# ADDENDUM NO. 1 TO PROJECT NO. TMUA-W 18-19 C2 A.B. JEWELL WATER TREATMENT PLANT CLARIFIER NO. 3 IMPROVEMENTS

# PROJECT NO. TMUA-W 18-19 C2 AB JEWELL WATER TREATMENT PLANT CLARIFIER NO. 3 IMPROVEMENTS

<u>Drawings:</u> **05-E-100**

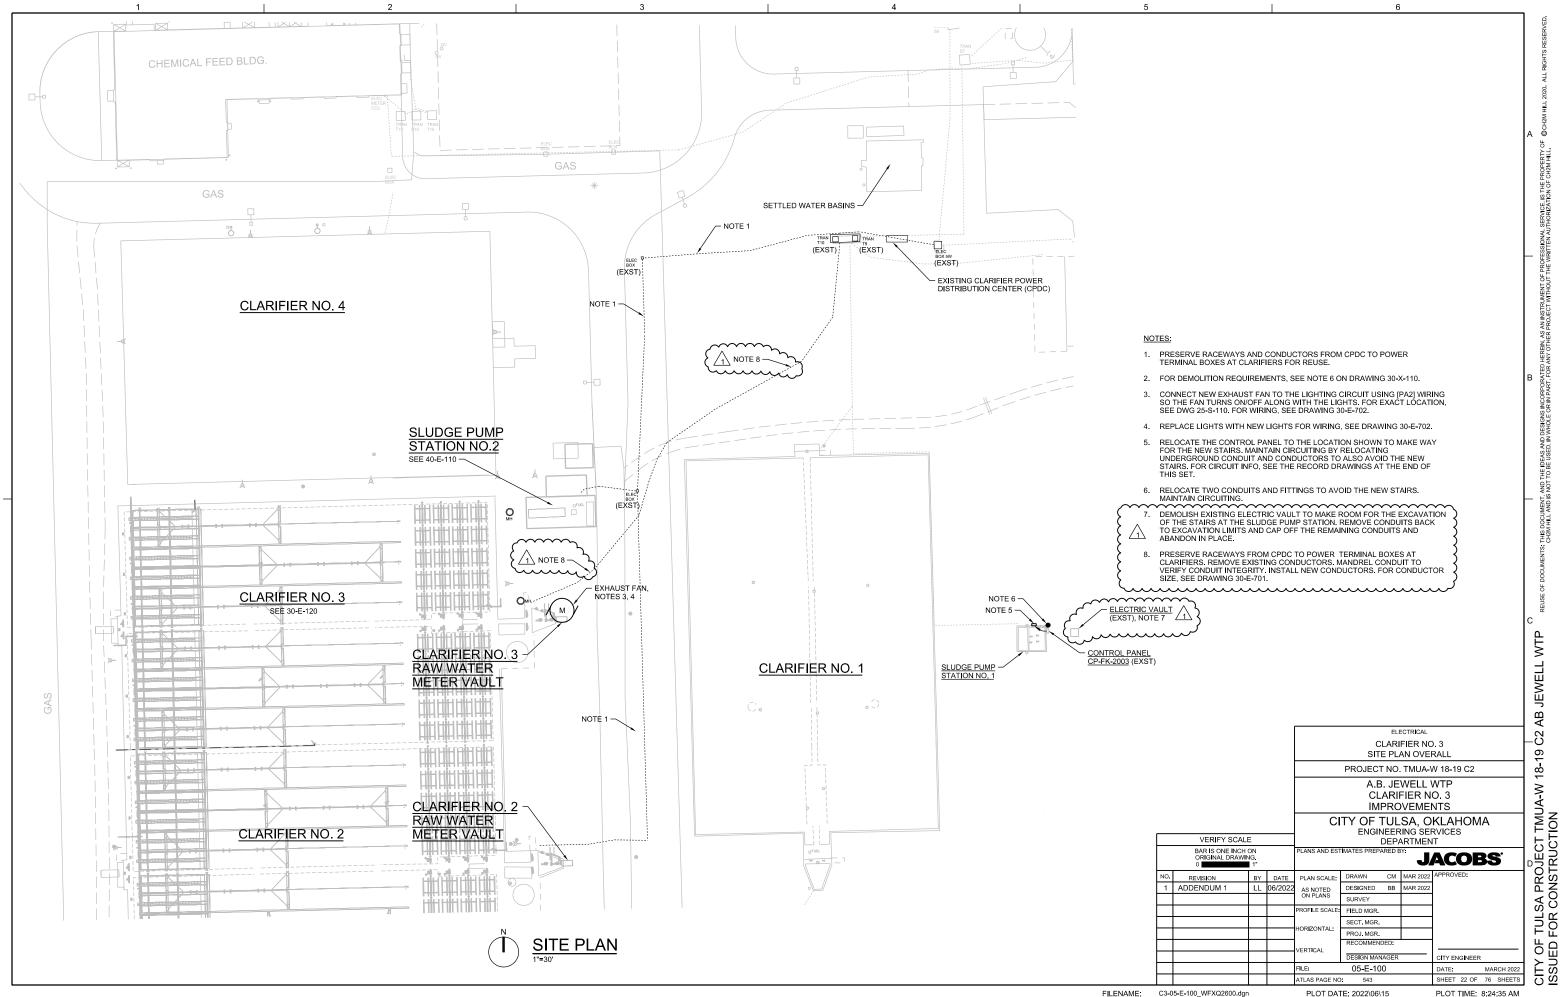
- 6) **05-E-100, ADD** Notes 7 and 8 that include demolition of the electrical vault near Sludge Pump Station 1 and replacing the Clarifier 3 wiring from the CPDC to the clarifier. The electrical vault demolition shall be included in Pay Item 04, and the Clarifier 3 wiring shall be included in Pay Item 53. This change is also reflected in Drawing **30-E-701**.
- 7) **30-E-601, CHANGE**, the breakers in MPC-L4 for VLV 10309 through VLV 10304 shall be 50 amp instead of 40 amp.
- 8) 30-E-703 and 40-E-110, CHANGE, the monorail hoist was installed in a previous project and shall not be installed in this project.
